RE: 1422 Van Cleave Road NW
Grading and Drainage Plan
Stamp Date: 06/27/18
Hydrology File: G13D034

Based upon the information provided in your resubmittal received 06/27/2018, the Grading and Drainage Plan is approved for Building Permit.

DRAINAGE AND GRADING PLAN

1422 VAN CLEAVE ROAD NW RESIDENCE

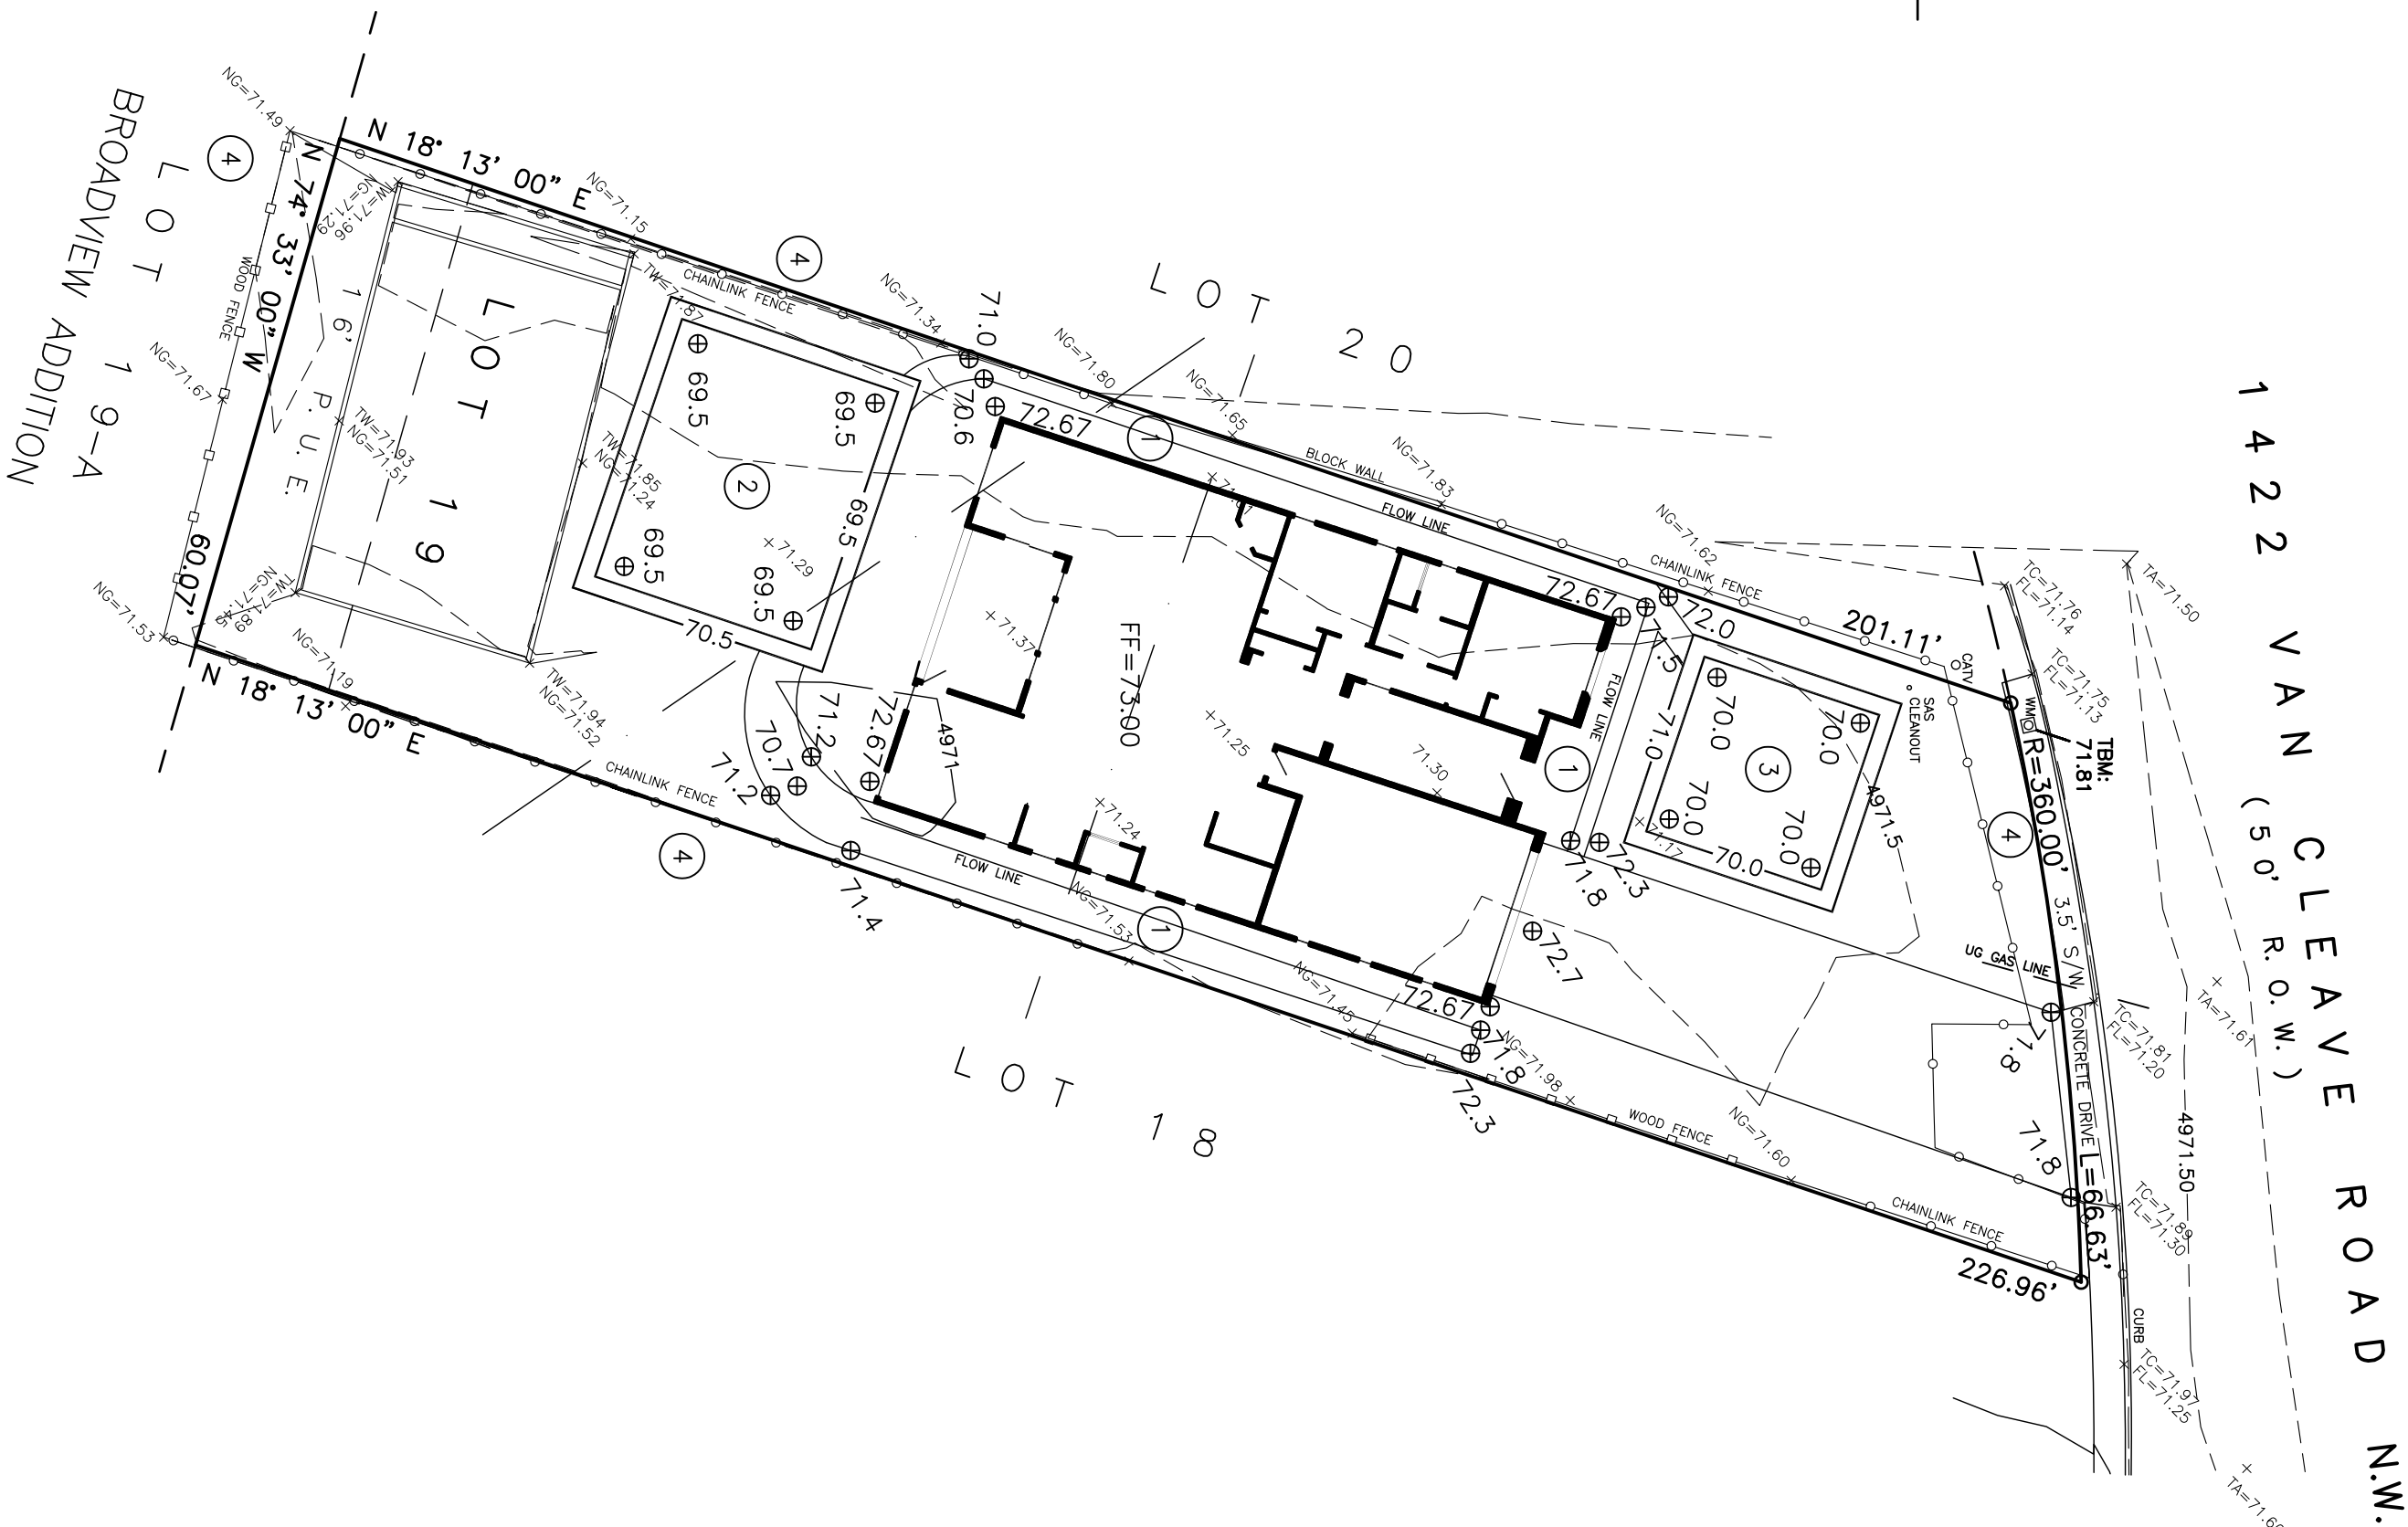
Once the grading is complete, a pad certification will be required prior to release of Building Permit. Please attach a copy of this approved plan in the construction sets for Building Permit processing along with a copy of this letter and the pad certification approval letter.

Prior to approval in support of Permanent Release of Occupancy by Hydrology, Engineer Certification per the DPM checklist will be required and a formal Elevation Certificate needs to be submitted to Hydrology.

Please provide a Private Facility Drainage Covenant per Chapter 17 of the DPM for retention ponds prior to Permanent Release of Occupancy. Please submit this on the 4th floor of Plaza de Sol. A \$25 fee will be required.
